## Errata Sheet V1.0

- The following datasheets:
  - AT91M42800A Summary, Rev. 1779AS-06/01
  - AT91M42800A, Rev. 1779A-06/01
  - AT91M42800A, Electrical Characteristics, Rev. 1776A-08/01
- 144-lead TQFP and 144s-ball BGA devices with the following markings:

AT91M42800A  
Errata Sheet  
V1.0

Rev. 1782B-01/02

**Figure 1. NWAIT Rising**

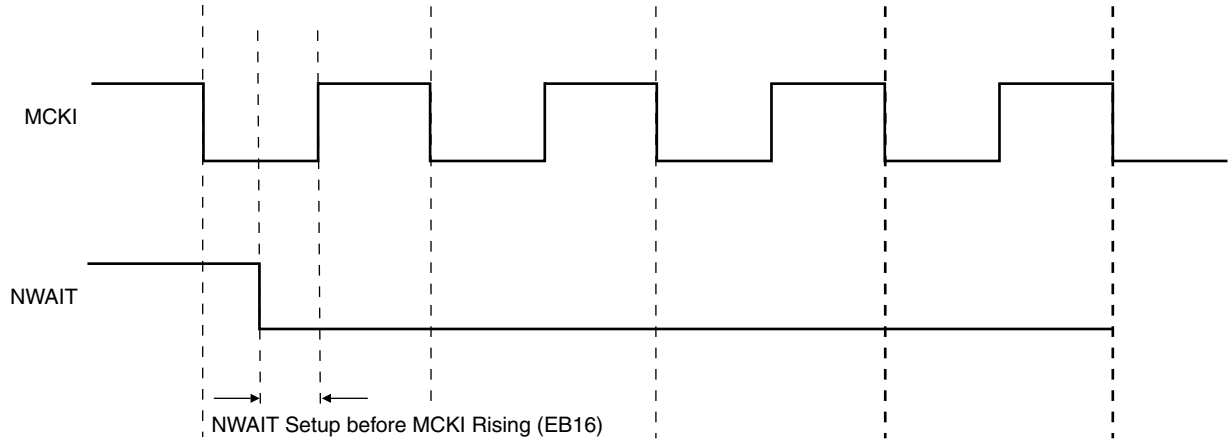
If the NWAIT setup time is satisfied on the first rising edge of MCKI, the behavior is accurate. The EBI operations are not affected when the NWAIT rises.

**Figure 2. Number of Standard Wait States is Two**

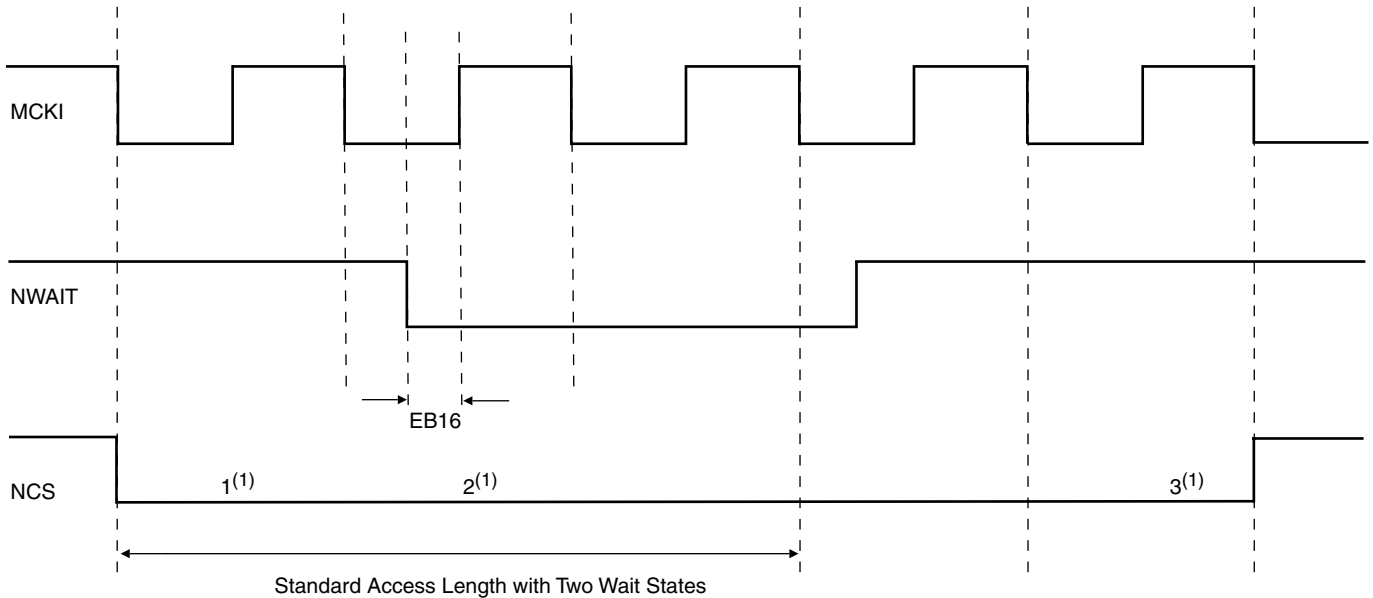
If the NWAIT setup time is satisfied on the following edges of MCKI and if at least one standard wait state remains to be executed, the behavior is accurate. In the following example, the number of standard wait states is two. The NWAIT setup time on the second rising edge of MCKI must be met.

**Figure 3.** Number of Standard Wait States is One

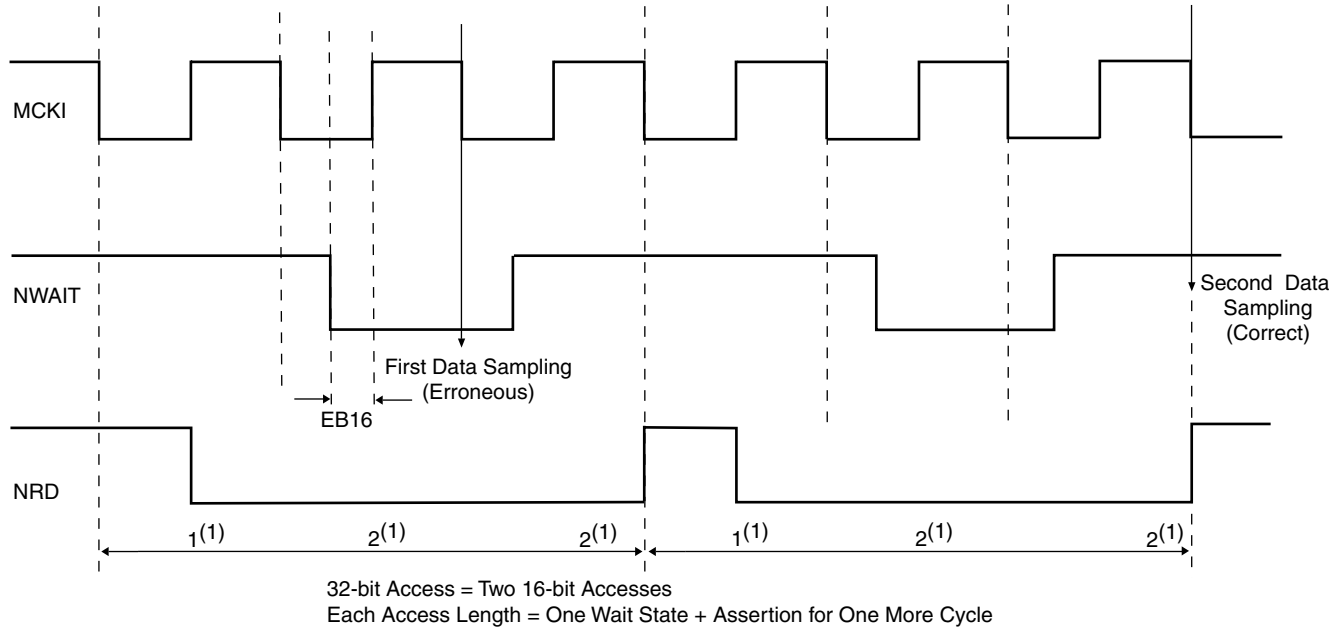
If the first two conditions are not met during a 32-bit read access, the first 16-bit data is read at the end of the standard 16-bit read access. In the following example, the number of standard waits is one. NWAIT assertions do affect both NRD pulse lengths, but first data sampling is not delayed. The second data sampling is correct.

At maximum speed, asserting the NWAIT in the first access cycle is not possible, as the sum of the timings “MCKI Falling to Chip Select” and “NWAIT setup to MCKI rising” are generally higher than one half of a clock period. This leads to using at least one standard wait state. However, this is not sufficient except to perform byte or half-word read accesses. Word and write accesses require at least two standard wait states.

**Figure 4.** Description of the Number of Standard Wait States

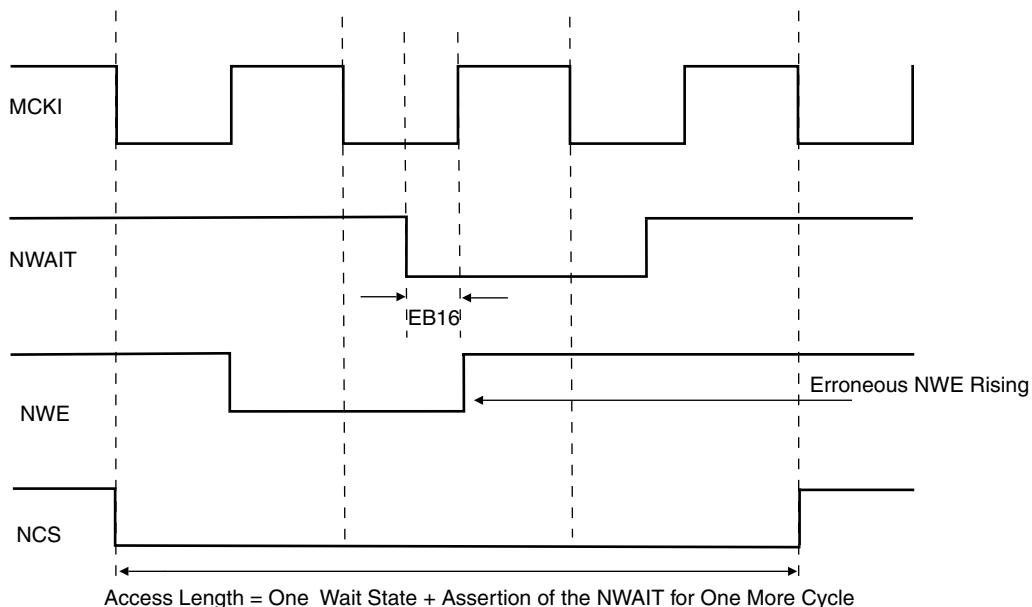
If the first two conditions are not met during write accesses, the NWE signal is not affected by the NWAIT assertion. The following example illustrates the number of standard wait states. NWAIT is not asserted during the first cycle, but is asserted at the second and last cycle of the standard access. The access is correctly delayed as the NCS line rises accordingly to the NWAIT assertion. However, the NWE signal waveform is unchanged, and rises too early.
